Lower Columbia River Fish Facility Design Review Work Group (FFDRWG)

February 2022 DRAFT Meeting Notes

February 3, 2022 09:00-11:00

- LPS alignment – **Schlenker**
 - See [TDA-Junction Pool Plan.doc](#) ([upload to FFDRWG meeting files website](#))
 - Plan view shows 2 ramps, a long traversing section LPS flow deflector 7' downstream of the first weir

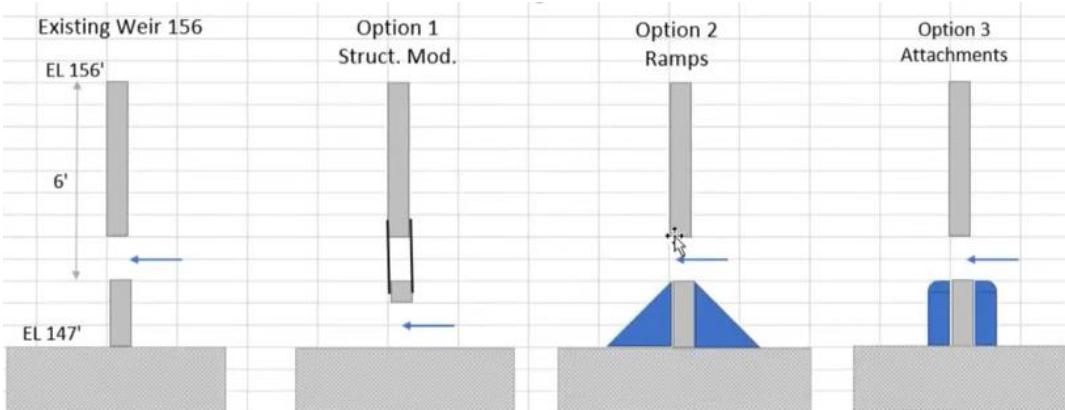
- Steep climbing ramps at the bottom, but usually underwater with only a 5' climb at the lowest tailwater elevations
 - from Kinsey Frick to everyone: I feel okay with the climbing and traversing designs. The location of the entrance/access is key. Are lamprey milling or using the entrance locations heavily?

- Entrance slot covers – Porter

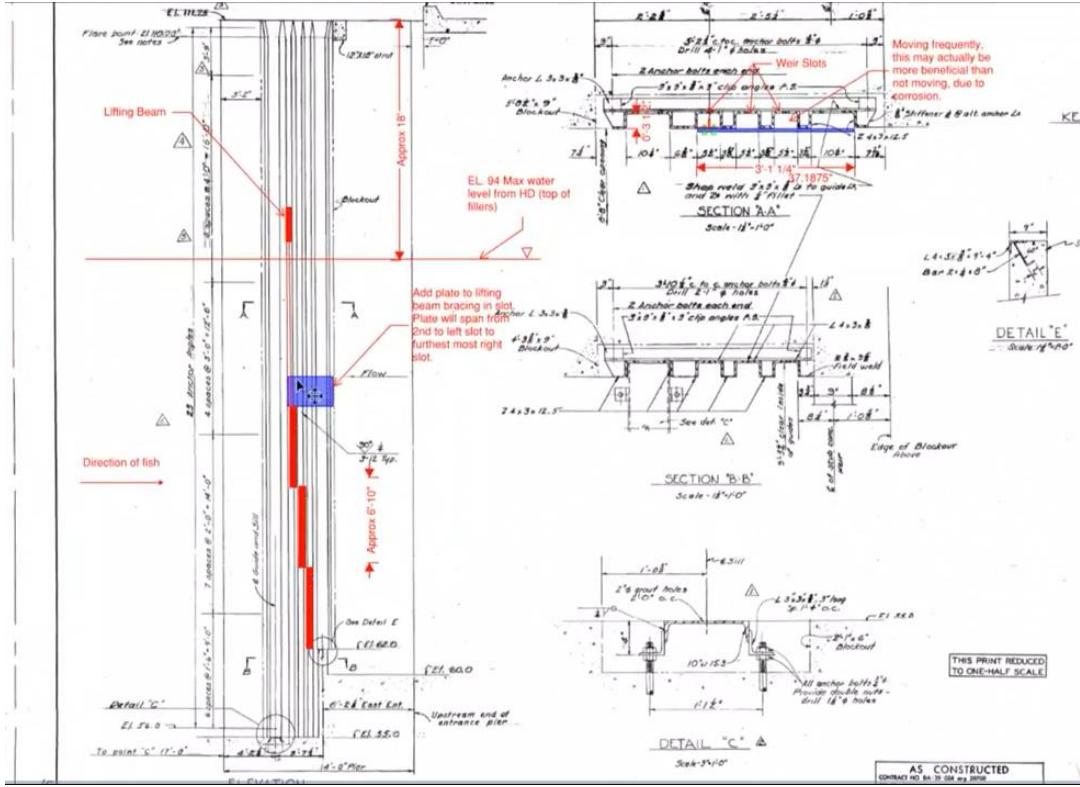
- Weight capacity of the lifting machinery may prevent us from installing covers from the weir crest to the water surface. FFDRWG (Kinsey Frick, Laurie Porter, Tom Lorz) recommends we put them at the weir crest and extend them as high as possible, within weight limits. Lamprey are more likely to approach the high velocity entrances from below, not so much at the surface.

c. Elevated orifices in B-Branch – **Derugin**

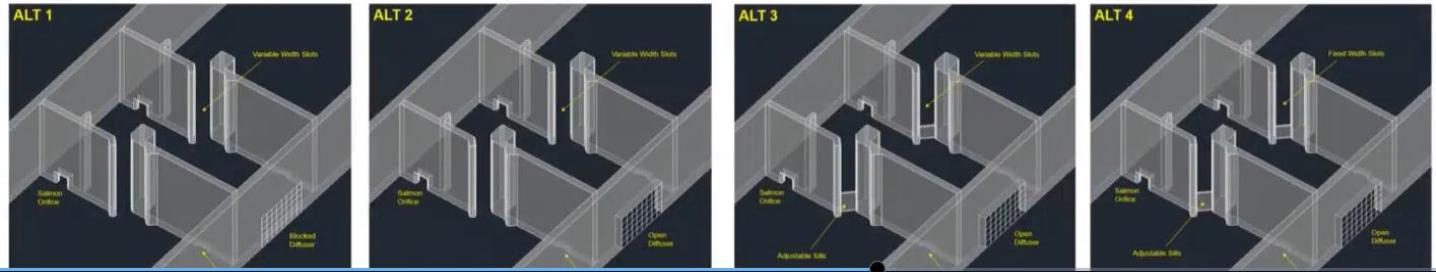
- BON staff are grinding the downstream lips of low-rise orifices, turning them into rounded ramps.
- The work shown in the photo represents “a few minutes” of work
- More grinding to be done to make it a smoother transition but so far it’s a promising proof of concept.
